09-041/14 - 2014-2015 MAZDA6 - REAR DOOR WEATHERSTRIP OUT OF POSITION

Subject: REAR DOOR WEATHERSTRIP OUT OF POSITION	Bulletin No: 09-041/14
	Last Issued: 09/24/2014

- This bulletin supersedes the previous bulletin 09-029/13, issued on 11/05/2013. The APPLICABLE MODEL(S)/VINS, REPAIR PROCEDURE, PART(S) and WARRANTY INFORMATION have been revised.
- Changes are noted below in Red beside the change bar.

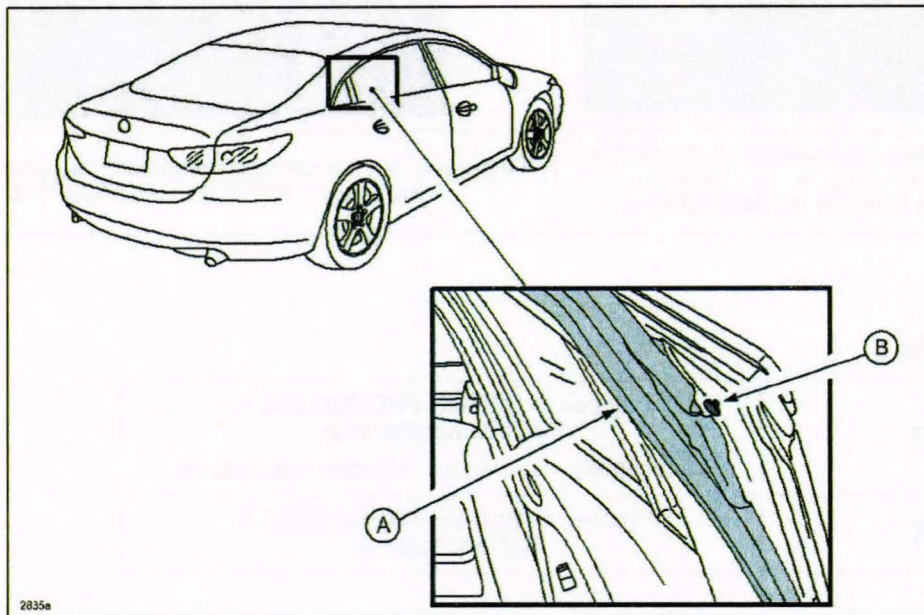
Some customers may have a concern with the top edge of the rear door weatherstrip (A) detached (coming off / falling off) from fastener (B).

REPAIR PROCEDURE A

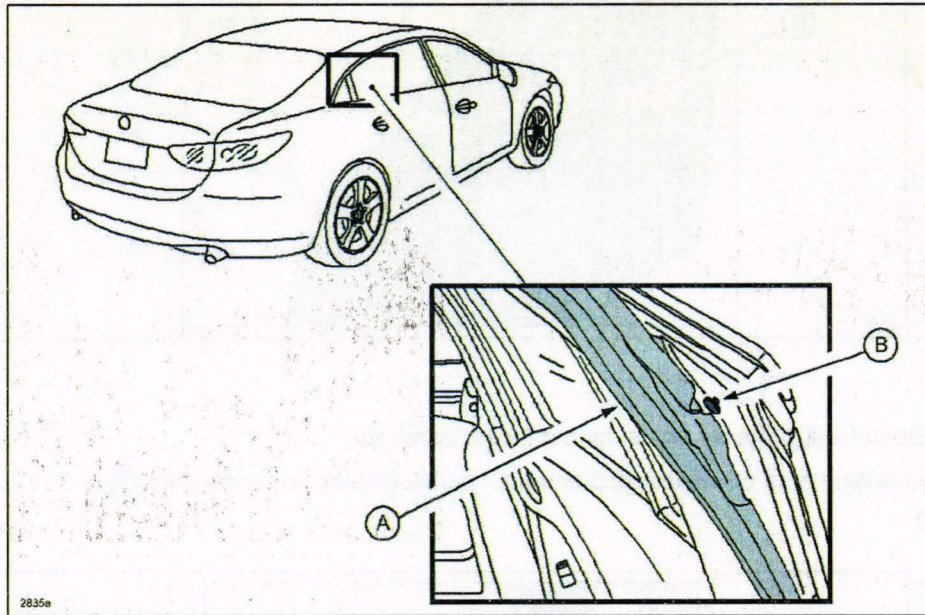
1. Install new rear door weatherstrip (A).

- New weatherstrip includes new fastener (B), part number GHP9-58-762A.
- It is NOT necessary to attach the new weatherstrip to the door panel using an adhesion bond.

REPAIR PROCEDURE B

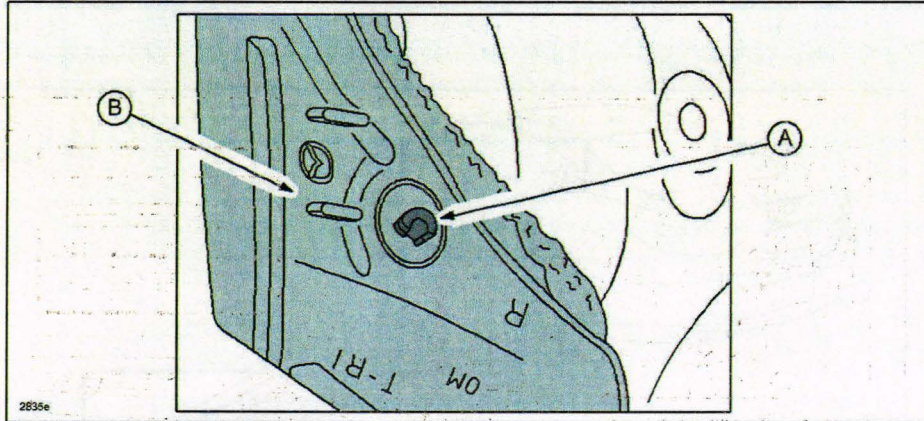
1. Install new fastener (A) to rear door weatherstrip (B).

NOTE: Do not install the weatherstrip to the door panel yet.

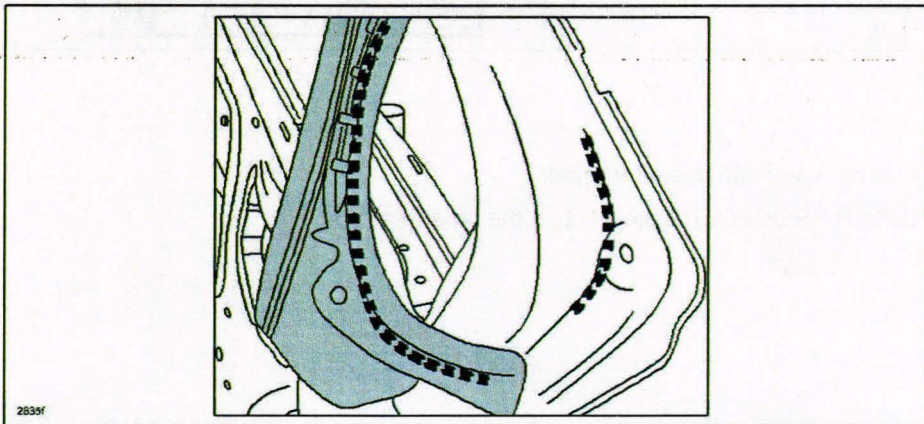
2. Clean the bonding area of weatherstrip and door panel. (Dotted line area of image).

3. Apply a 4 mm round bead (B) to the outside of the ethylene-propylene terpolymer (EPT) sealer (C) starting from point (D). Continue bonding as shown in the dotted line (E) up to 10 mm below R or L mark (F).

NOTE: Minimize bond waste by not applying more than 10 mm below R or L mark (F).
